01 Floor plans

Level 02 Floor Plan

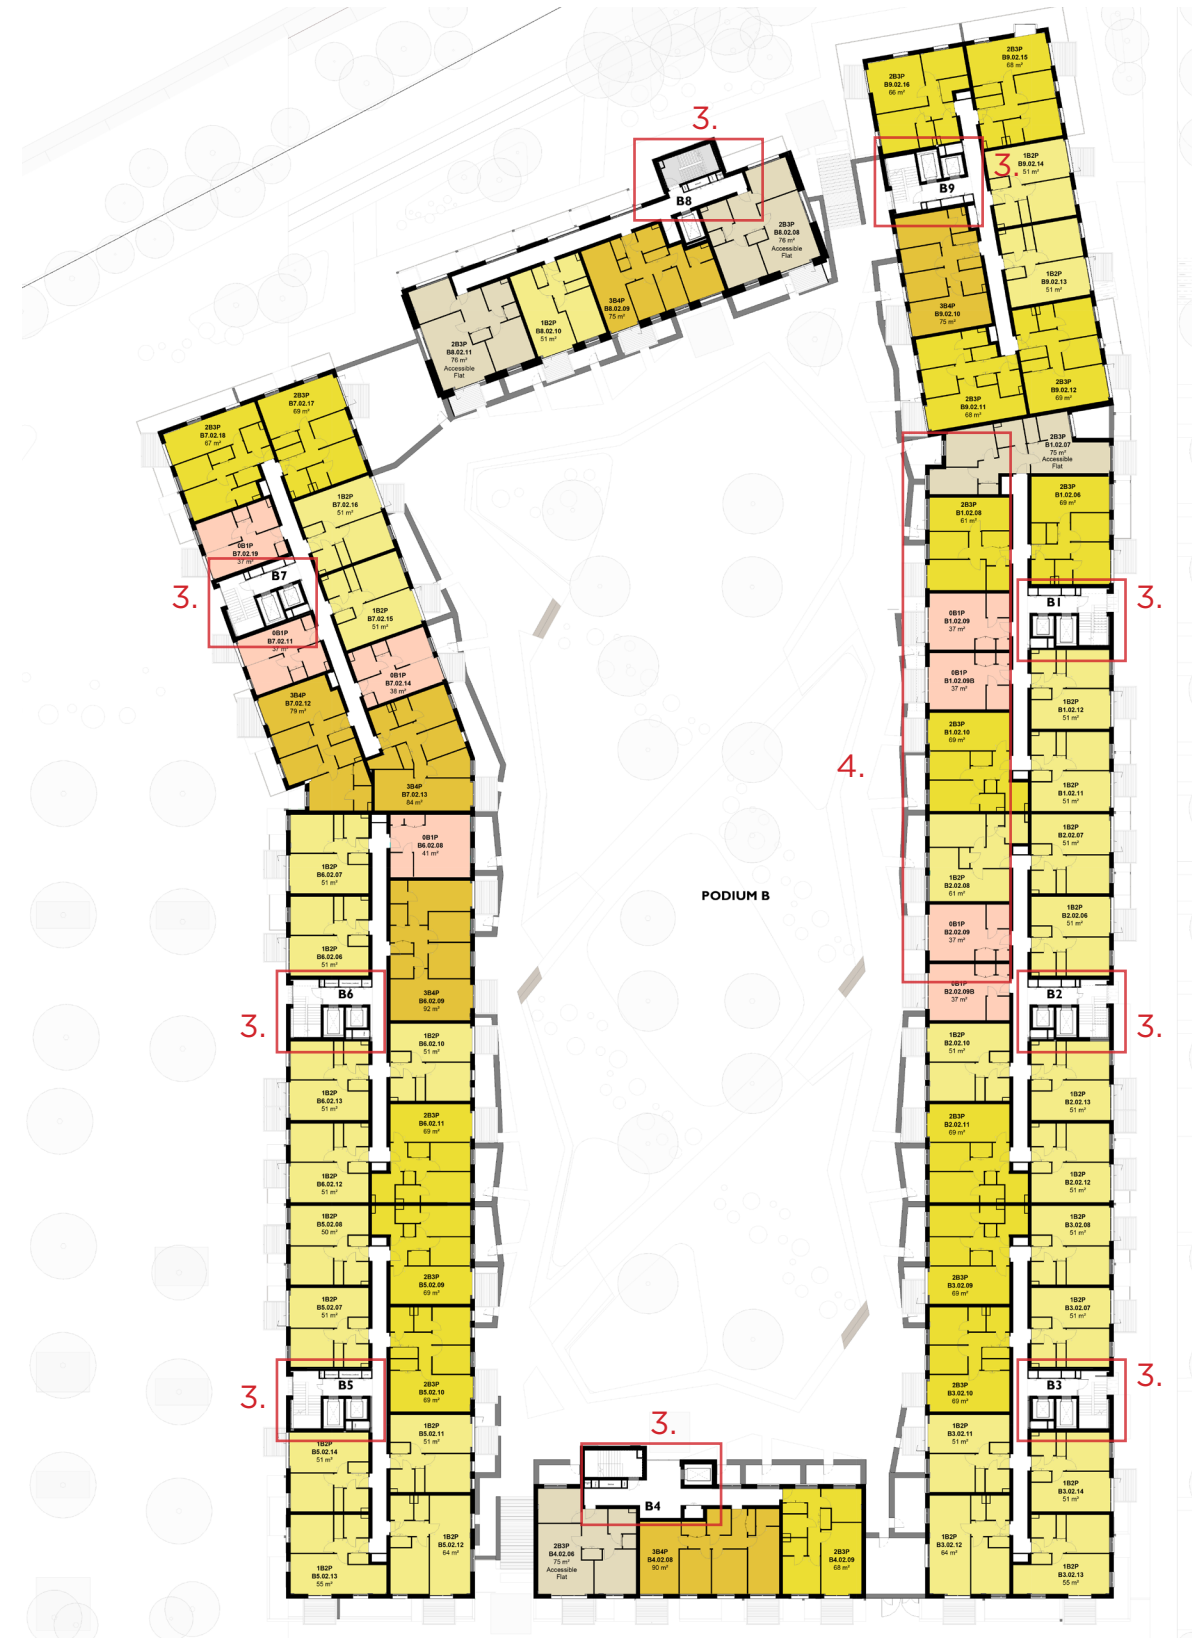
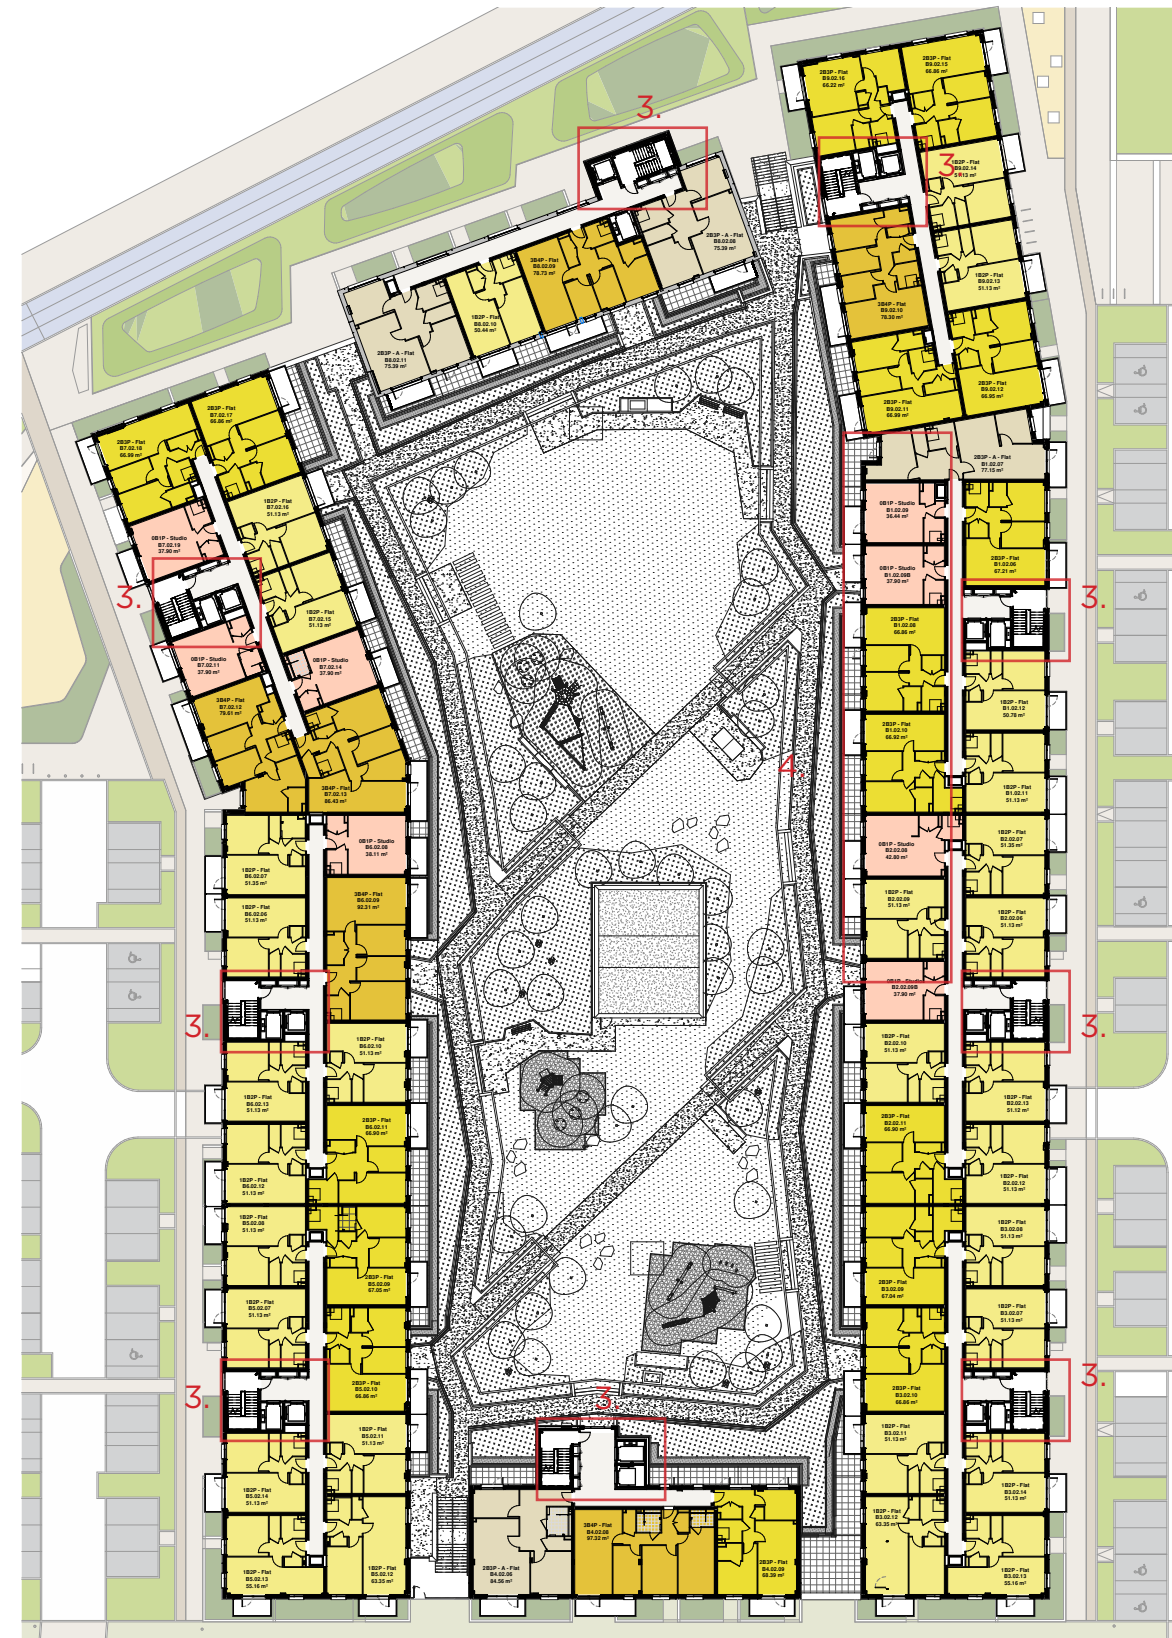
1. Omission of podium entrance canopies; security risk to adjacent apartments at first floor.
2. Addition of plant housing for car park smoke extract fans as per developed fire strategy
3. Updated core layout as per developed fire strategy; evacuation lifts added to Blocks 4 and 8
4. Reconfiguration of apartment layout. Overall mix remains as consented.

Level 03 Floor Plan

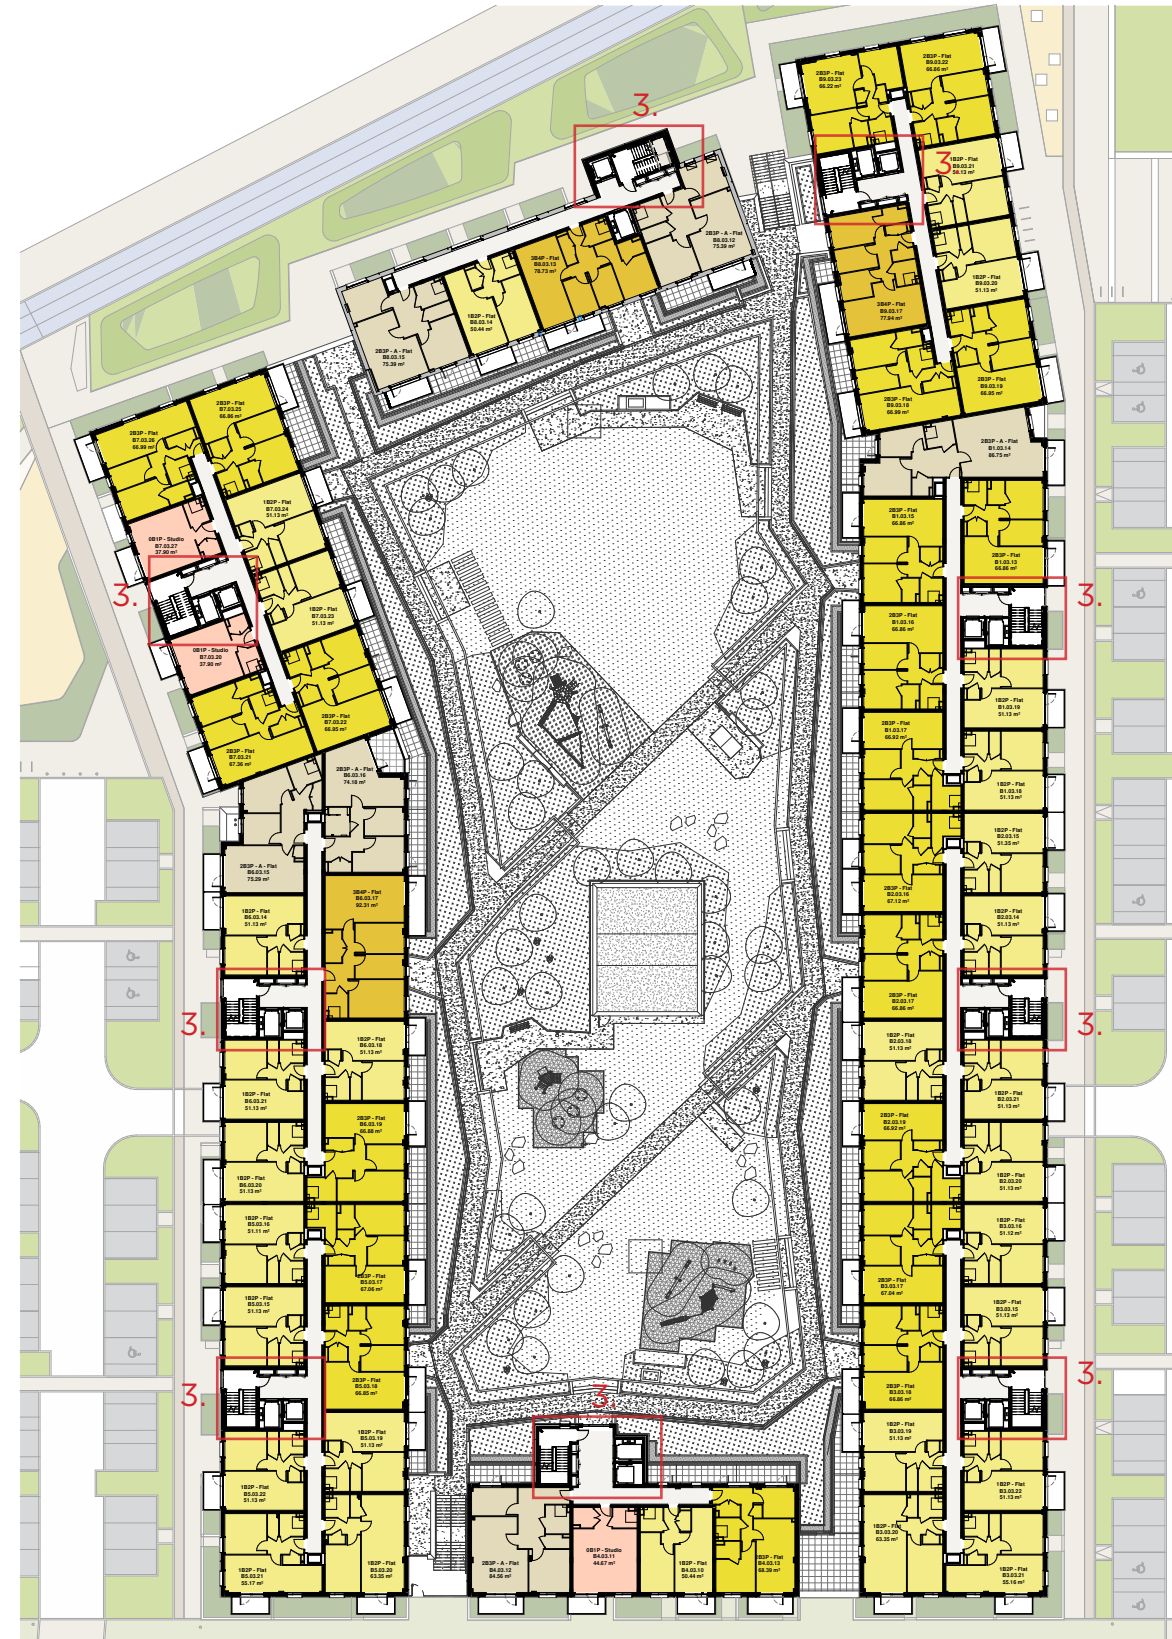
1. Omission of podium entrance canopies; security risk to adjacent apartments at first floor.
2. Addition of plant housing for car park smoke extract fans as per developed fire strategy
3. Updated core layout as per developed fire strategy; evacuation lifts added to Blocks 4 and 8
4. Reconfiguration of apartment layout. Overall mix remains as consented.
